**Errata: CS43L43 Rev. D**CS43L43 Low Voltage, Stereo DAC with Headphone Amp

All references to the CS43L43 mentioned below shall be taken to refer to revision D of the CS43L43 product. The hardware revision code can be found in the 10-character field printed below the part number on each chip. The letter which appears as the fifth character from the right is the revision code (e.g. ZNACSD9926 is a Revision D part).

Figure 1. Pop Guard Fix

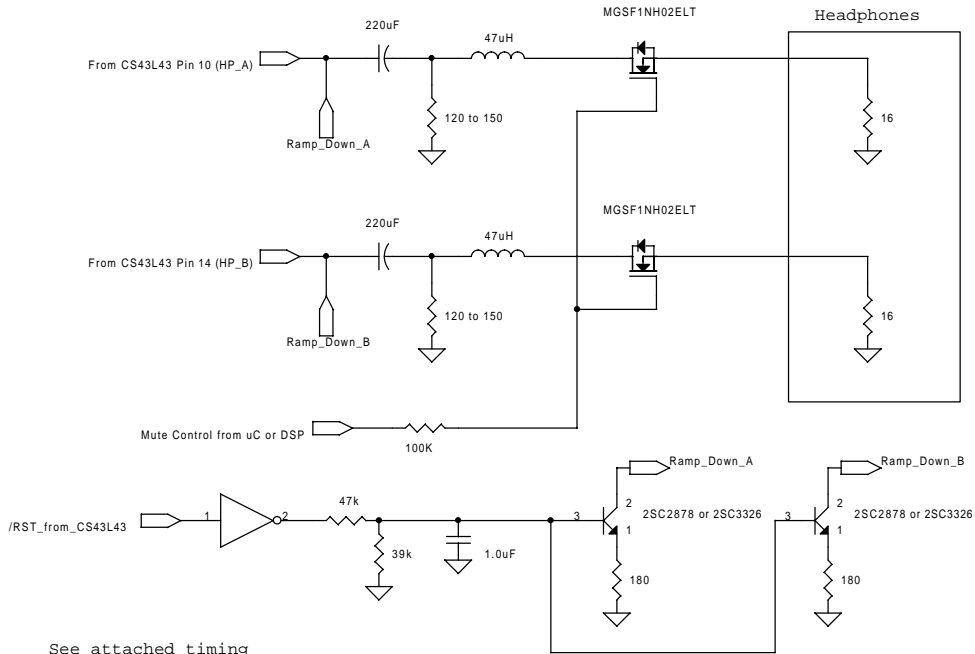
- The PopGuard<sup>®</sup> Transient Control does not function properly and will produce audible artifacts on the headphone outputs during power-up. A hardware fix is available for this issue and is shown in Figures 1 and 2.

- The PopGuard<sup>®</sup> Transient Control power-down ramp requires 5 seconds to prevent audible artifacts on the headphone outputs at the next power-up. A hardware fix is available for this issue, see Figures 1 and 2 for details. This fix will reduce the ramp down time to approximately 300 milliseconds.

The Motorola MOSFETs shown have been tested to work properly, however, an equivalent device may be used.

2SC2878 is in TO-92 package  
2SC3326 is in SOT-23 package

The Toshiba transistors or equivalent will work best here. The device used must have a very low Ron (3 ohms or less).
